LIST OF SPECIAL INFORMATION EXPEDITOR

(This EO replaces EO 05-45B-5A dated 26 Aug 66)

TABLE OF CONTENTS

Figure 1. Teflon Strip Location.

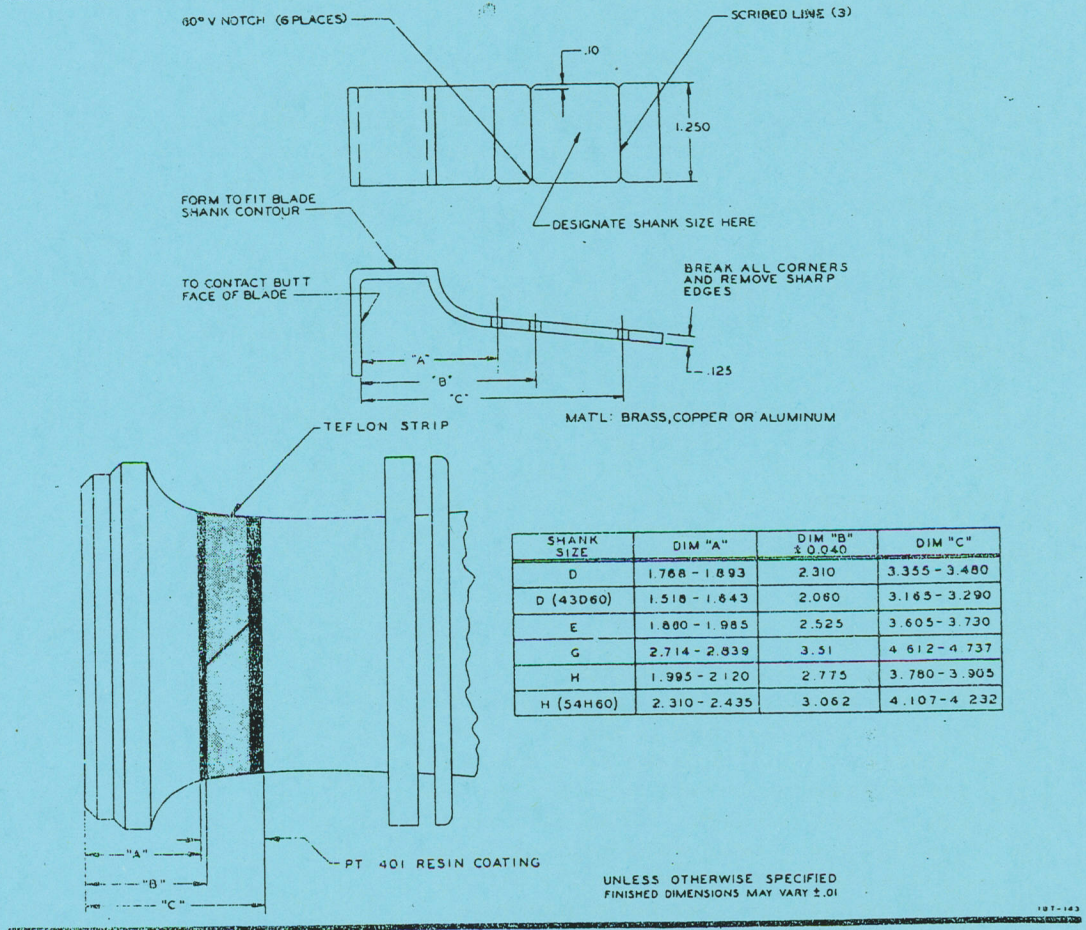
4. Apply a brush coat of PT 401 black resin to the area shown in Figure 1. PT 401 resin is a mixture by volume of 16 parts PT 401 resin and 1 part H-10 hardener. The resin has a pot life of 12 hours. Allow the resin to dry on the blade shank for 20 minutes. Apply a second coat and allow to dry until such time as the resin surface will not be marred or damaged by subsequent operations such as taping. This time will exceed one hour. Insure that the resin coating is continuous.

5. Outline with masking tape that portion of the PT 401 resin coating to be covered by the Teflon strip as shown in Figure 1. A marking guide as shown in Figure 1 may be used.

Figure 1

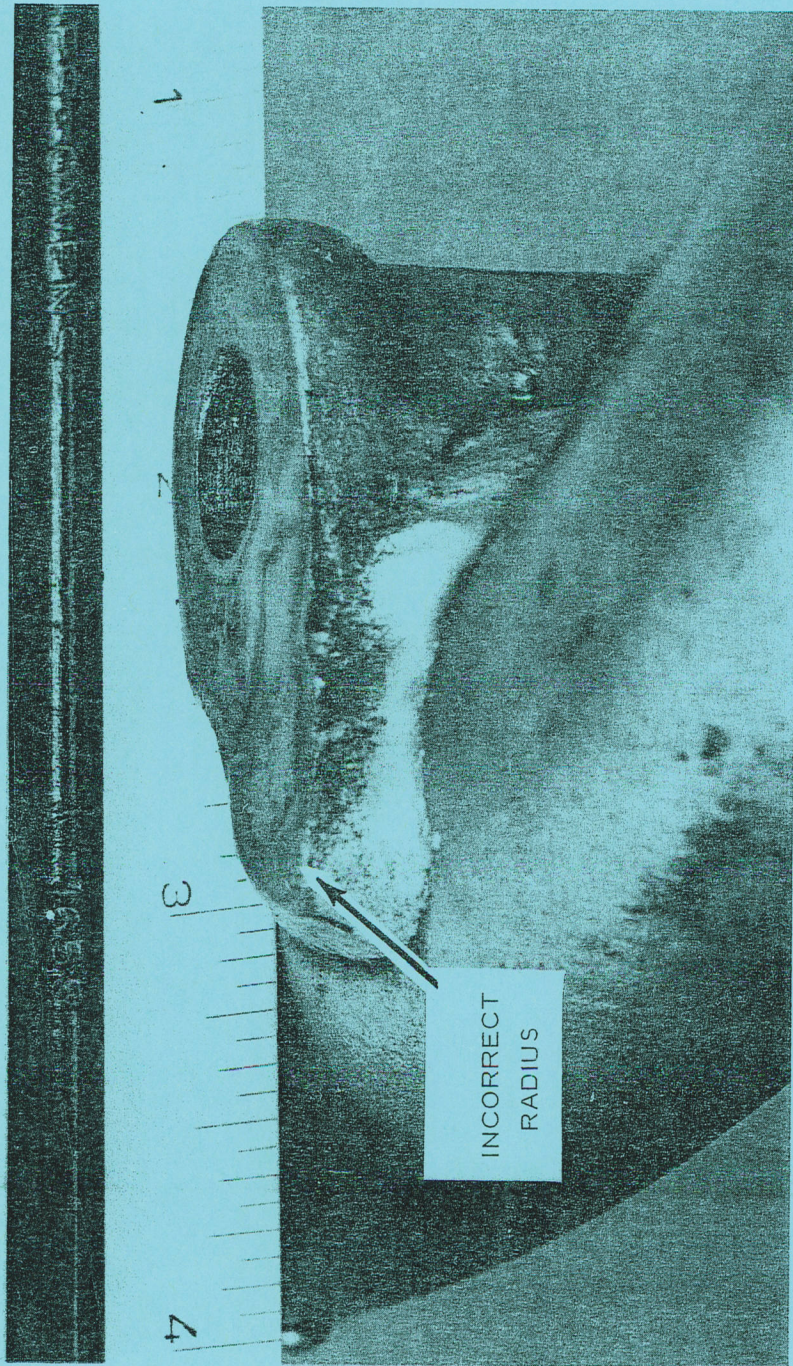
1 The purpose of this Engineering Order is to bring to the attention of operating units, that improper machine finish of engine mount brackets (refer to Figure 1) have been reported from the field. Such a condition results in inner cowling cracks when engine mount brackets come in contact and wear on the curvature of inner cowling ring.

Figure 2

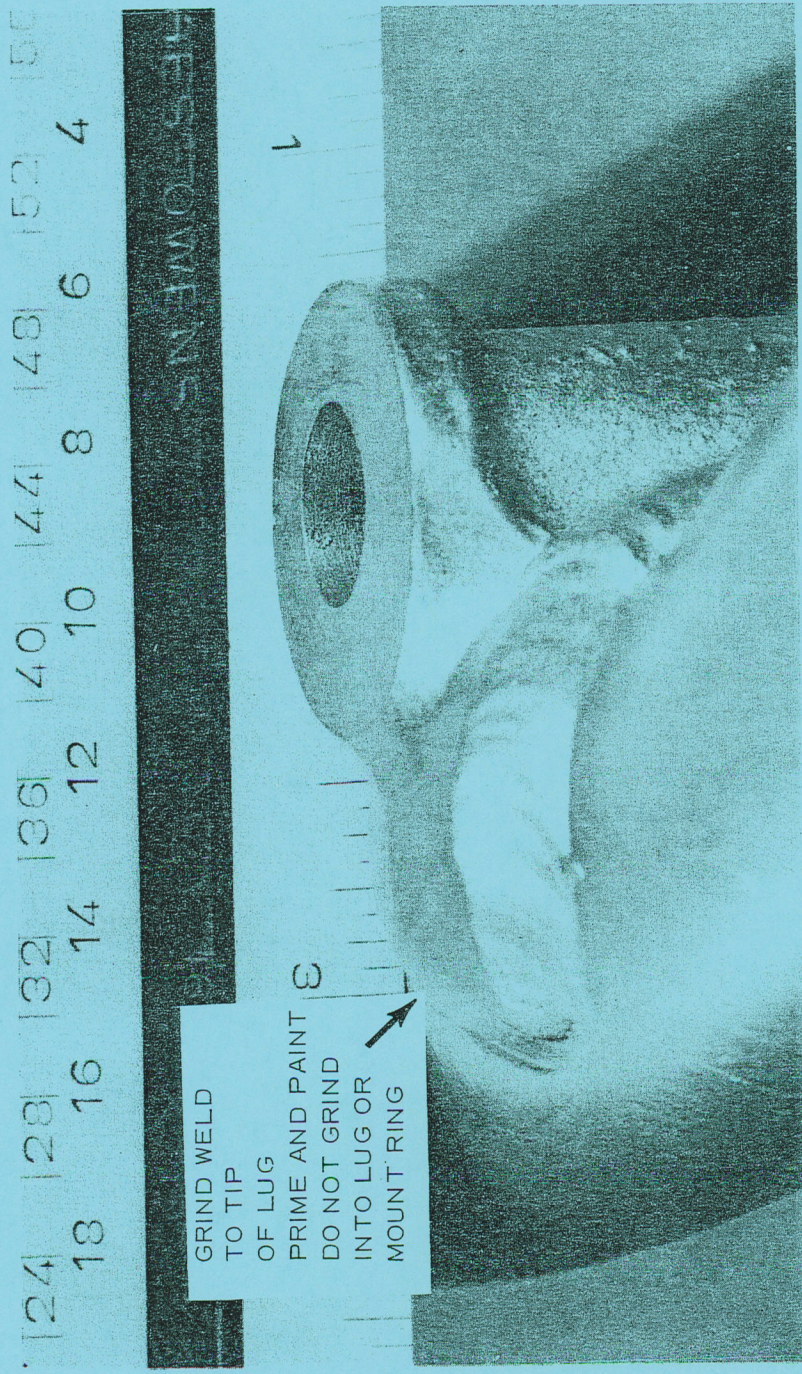
2 Rework of engine mount attachment lugs by grinding to remove interference between inner cowling and mount is permissible. The weld may be ground back to the lug as indicated in Figure 2. The extent and procedure of rework is to be rigidly controlled to ensure that bracket lug or engine mount ring are not ground into.

Improper grinding in this area may induce fatigue problems and could seriously affect the strength of the engine mount.

3 After grinding the affected areas are to be primed and painted.

Figure 1

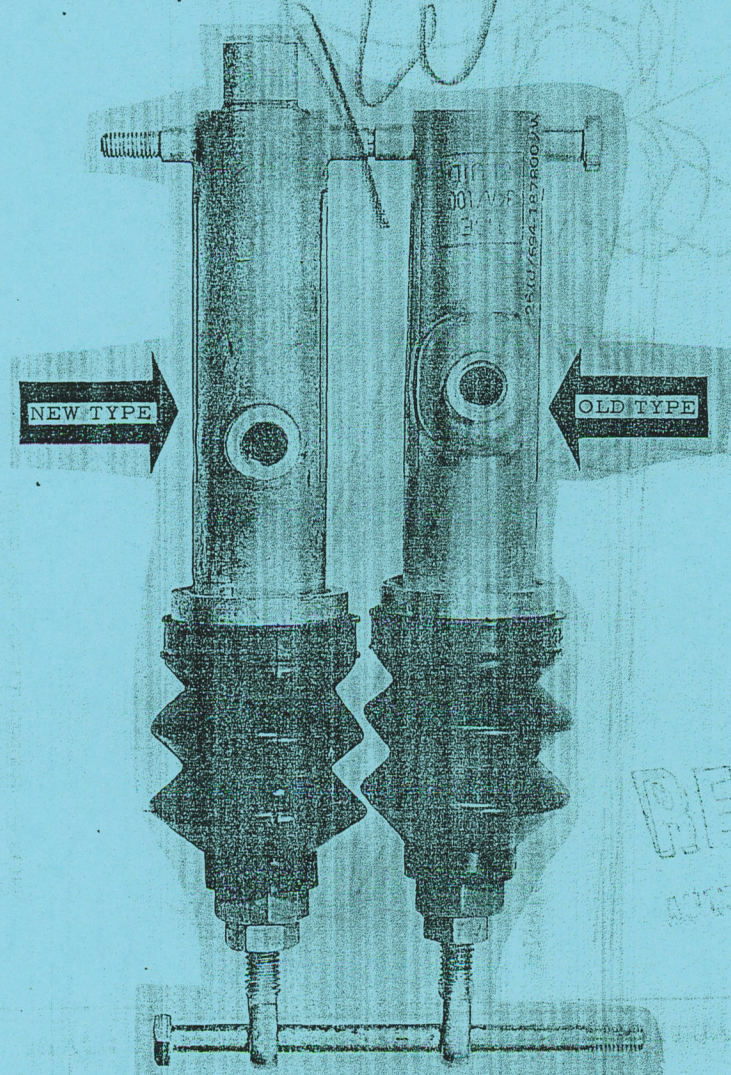
1 Further to the problem outlined in EO 05-5B-5A/21, an additional snag has been encountered by one operator when installing the latest design of Part 694-187800 cylinders. It will be noted from Figure 1 that the inlet boss on the later type of cylinders is located further aft than on the older type and is of increased height; on some aircraft installation of these later type cylinders on the co-pilot side will result in chafing of the rudder balance cable on the tee or elbow inlet fittings. The older type are quite satisfactory in any location.

2 Since there are approximately 1400 of the old type and only 120 of the later version it is recommended that whenever possible the new ones be reserved for use on the pilot side. When this becomes impossible or impractical bridging of the balance cable may be effected by local manufacture of a tube assembly and fitment as shown in Figure 2.

Figure 1

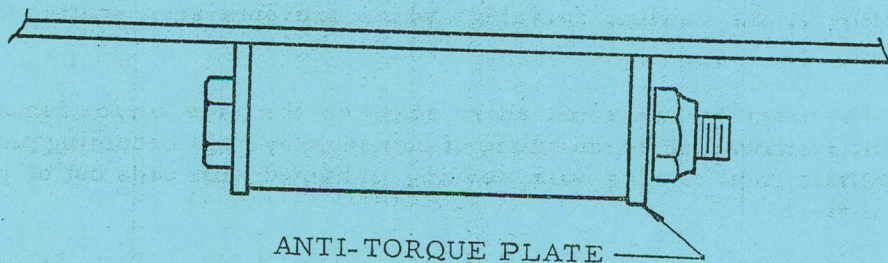
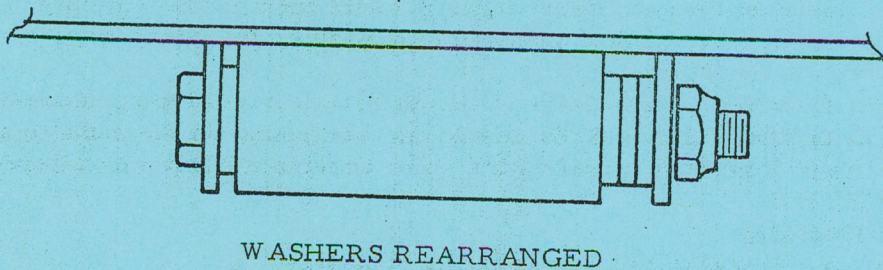
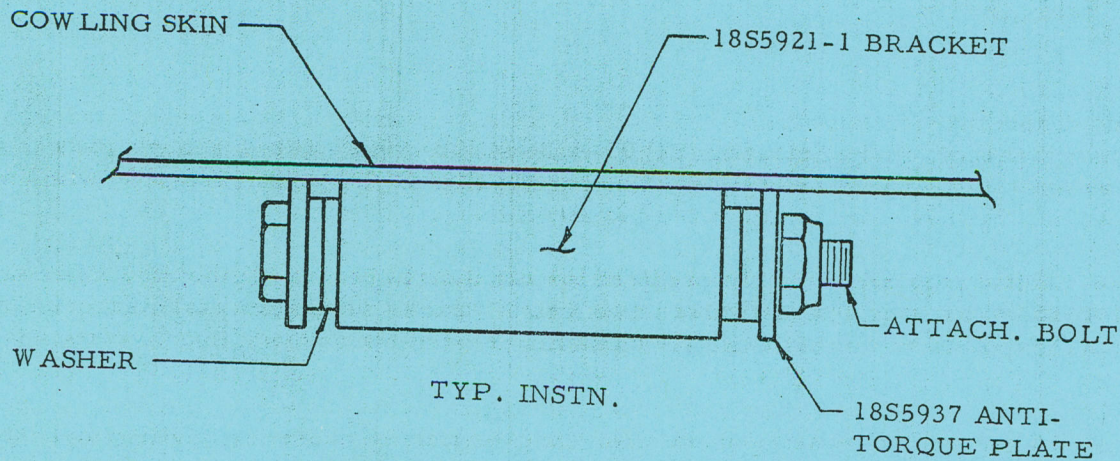
- 6 Cowling adjustment as outlined in EO 05-45B-5A/31 together with the following should be practised where applicable:-
- (a) Where brackets are misaligned or cowling contour is not as desired, judicious use of a rubber mallet may be necessary.
 - (b) On brackets with positioning plates so positioned as to prevent upper and lower cowlings mating, alter the number of washers on each side as applicable to rotate cowling position, refer to Figure 1.

INSTALLATION WITH NO WASHERS PRIOR
TO EMBODIMENT OF EO 05-45B-6A/85
THIS INSTN. REQUIRED FOR PROPOSED
MODIFICATION SHOWN FIGURE 2.

Figure 3

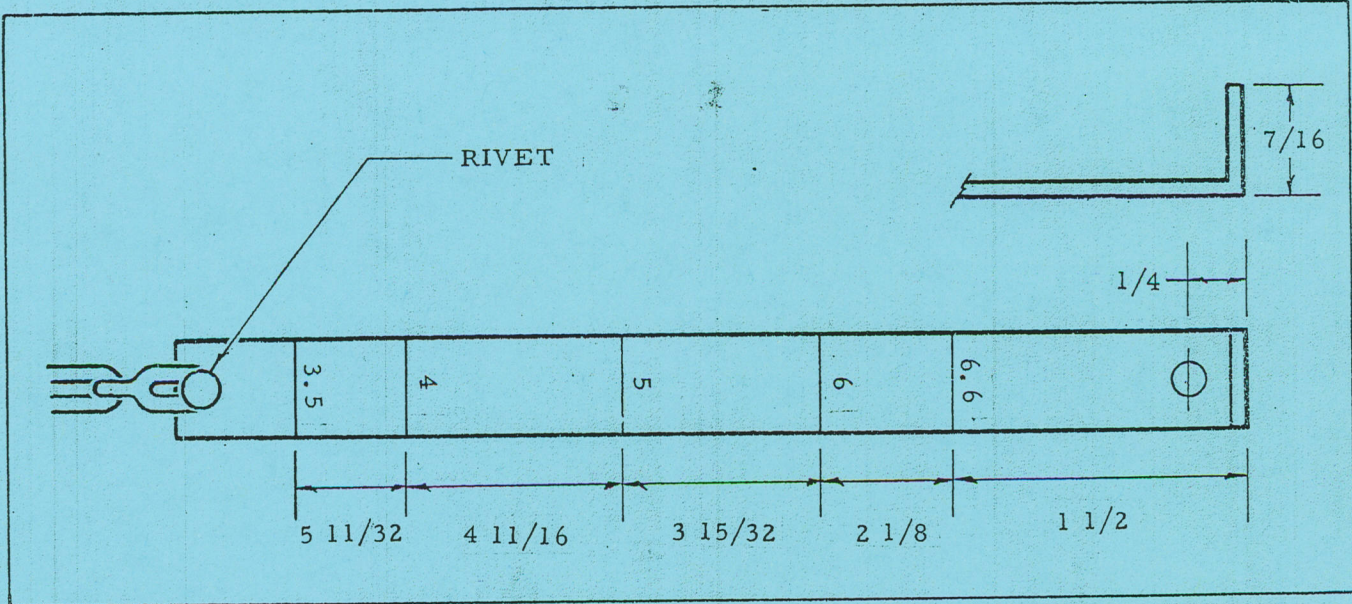
2 One unit also reports that, in the opinion of their technicians, the dipsticks are of value in preventing over or under filling the tank. These were originally omitted on the contractor's advice that installation on the new cap would increase the price considerably; since aircraft, such as the Harvard, managed to do without them, it was considered a non-essential item and accordingly left off. Operators who agree that the dipstick is desirable may utilize the one originally fitted to the old cap as shown in Figure 2. If the removed one is not available, local manufacture is recommended using Figure 3 as a reference.

Figure 1

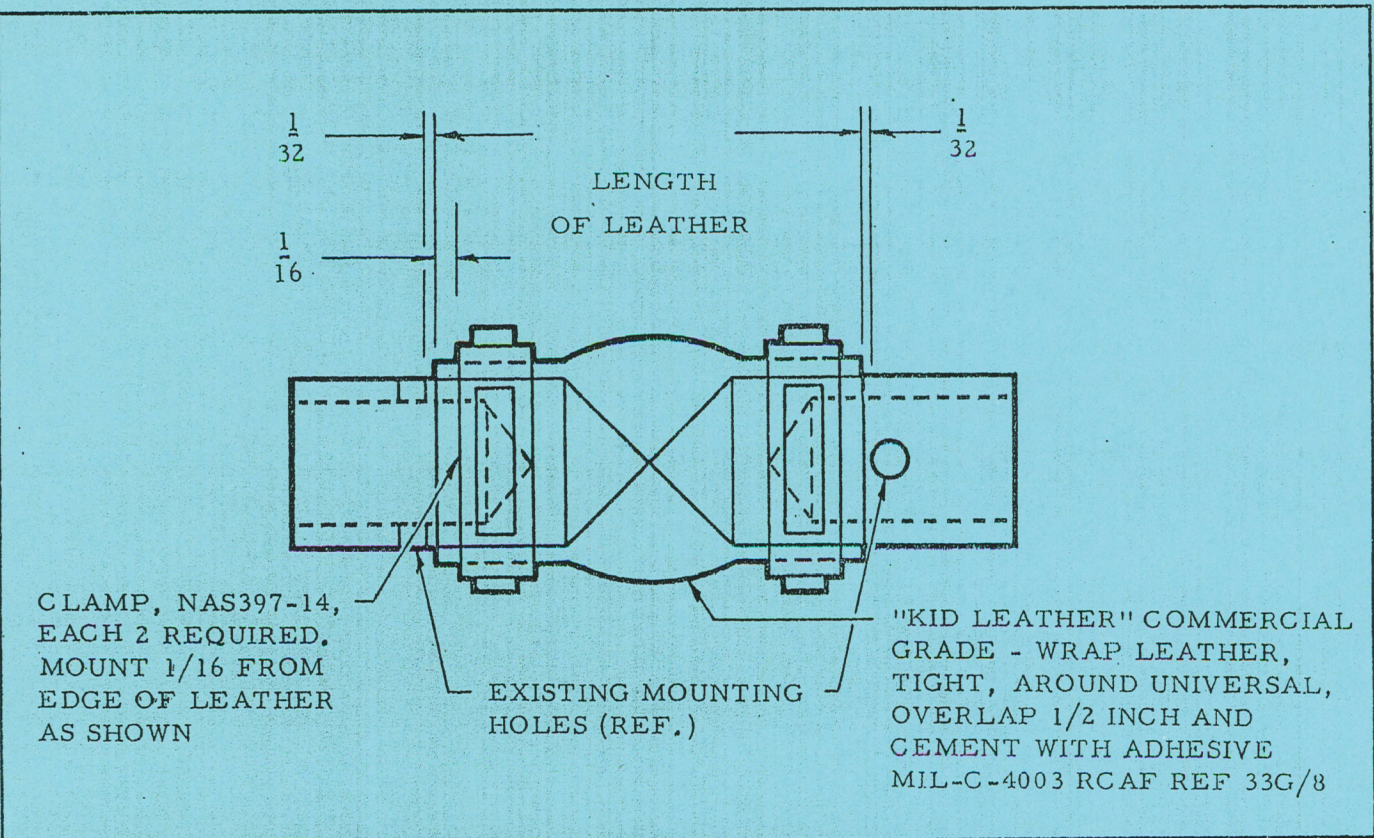
2 Since the dust boot retaining bands are a swage type it is only possible to remove the boot by cutting the bands. This should not be normally necessary unless the existing boot has deteriorated to the extent replacement is necessary. Replacement boots are to be locally manufactured from commercial grade "kid leather" and attached as outlined in Figure 1.

Figure 1

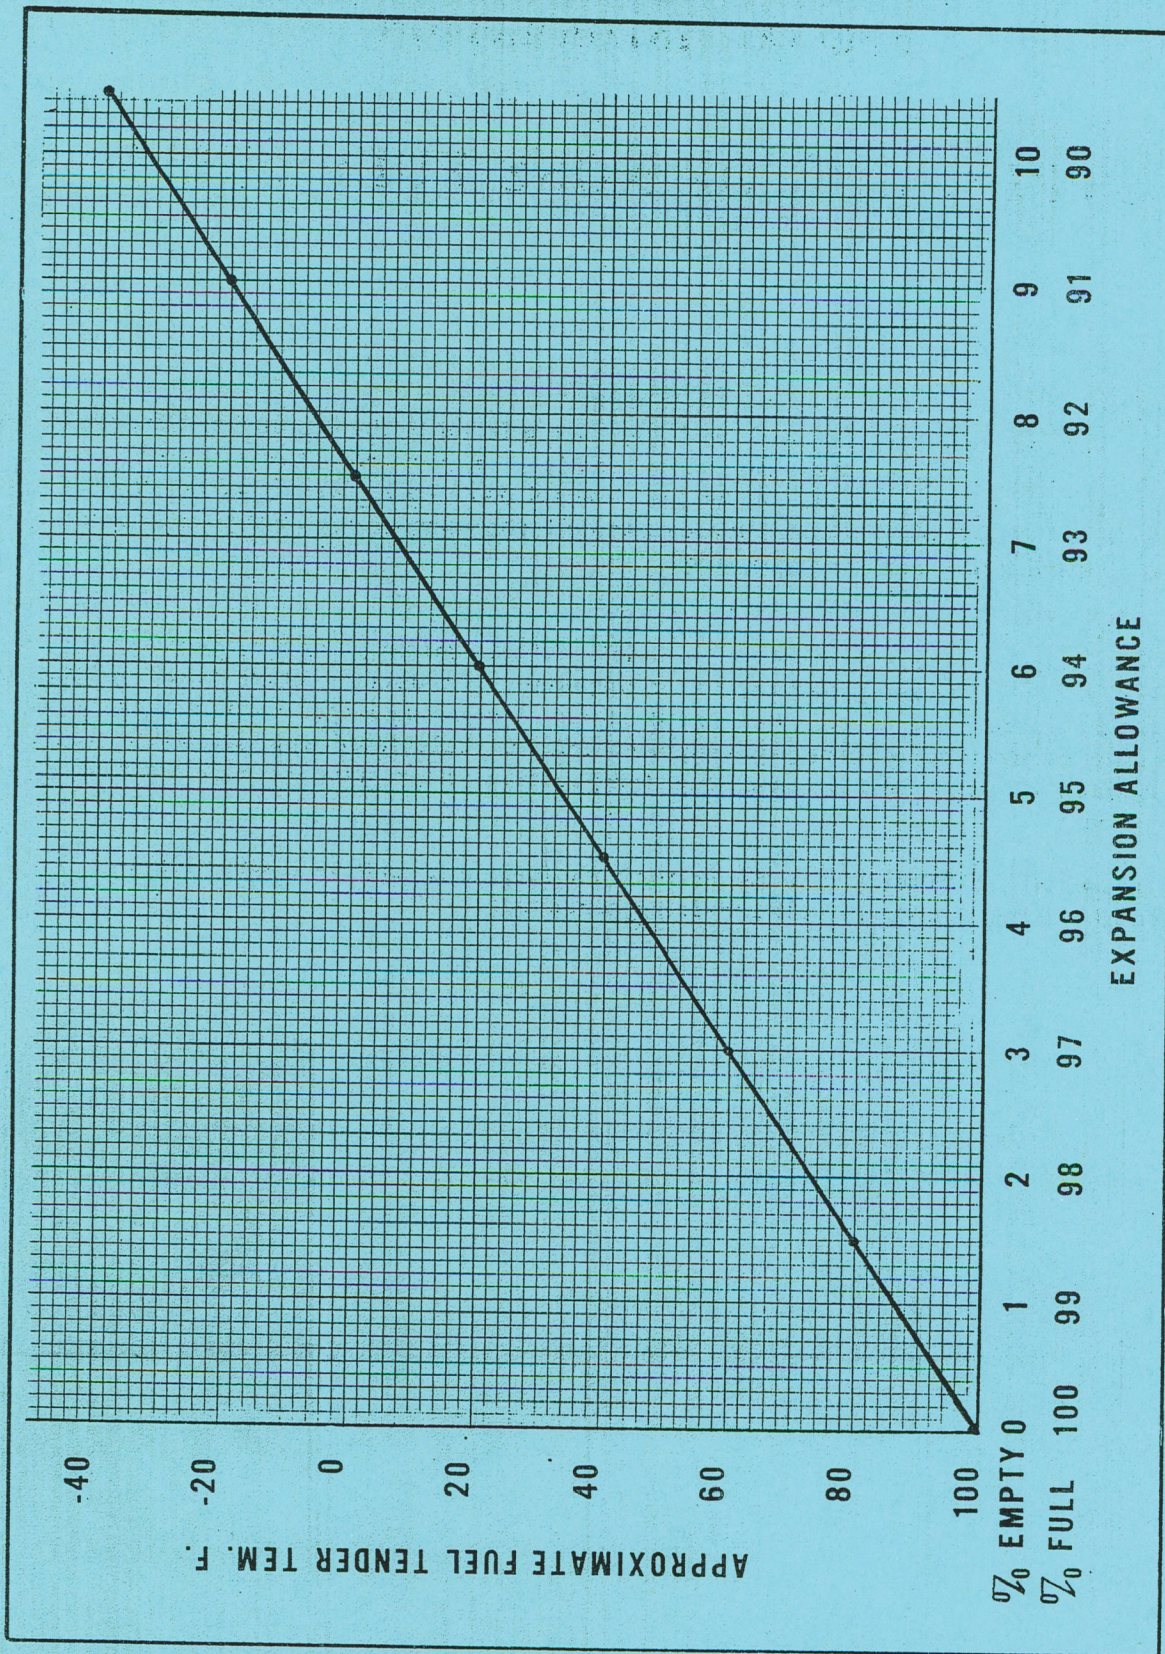
2 The seriousness of large amounts of aviation fuel spilled on hangar floors and thence to drainage and sewer systems cannot be over-emphasized. To obviate future cases of this nature ample provision for fuel expansion is to be made during refuelling Expeditor fuel tanks and cells. The necessary percentage of capacity reduction may be calculated approximately using 1 1/2 percent for each 20 degrees the tender fuel temperature is less than 37.8°C (100°F). Refer to chart in Figure 1.
